## NOTICE of Improvement of Drawer

For quality improvement of drawers of middle & large size safes model 060-130, current drawers are to be modified in design and reinforced with new 265mm long slide rails. The features of improvements are described hereunder.

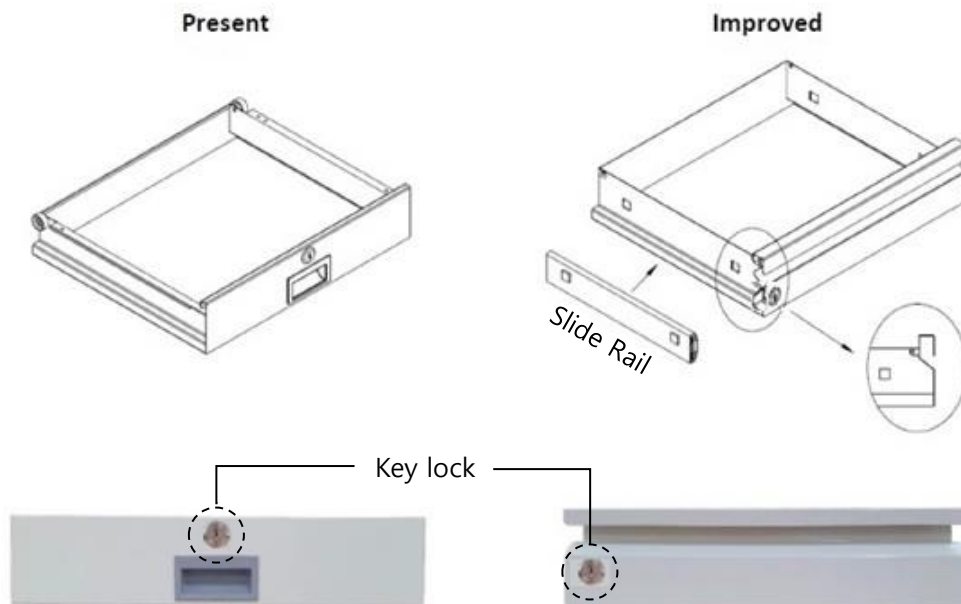
1. Drawer front face is designed simple grip with a cam lock, which is considered useful. It is confirmed that users can use the cam lock on drawer continuously.
2. When moving the improved drawer back and forth, there is no noise caused by friction. It works smooth with keeping flat and steady thanks to new slide rails.
3. Drawer's weight allowance increases up to 39kgs, 2.6 times more compared to current one's 15kgs.
4. We applied improved new drawer as of Nov. 18. 2019.
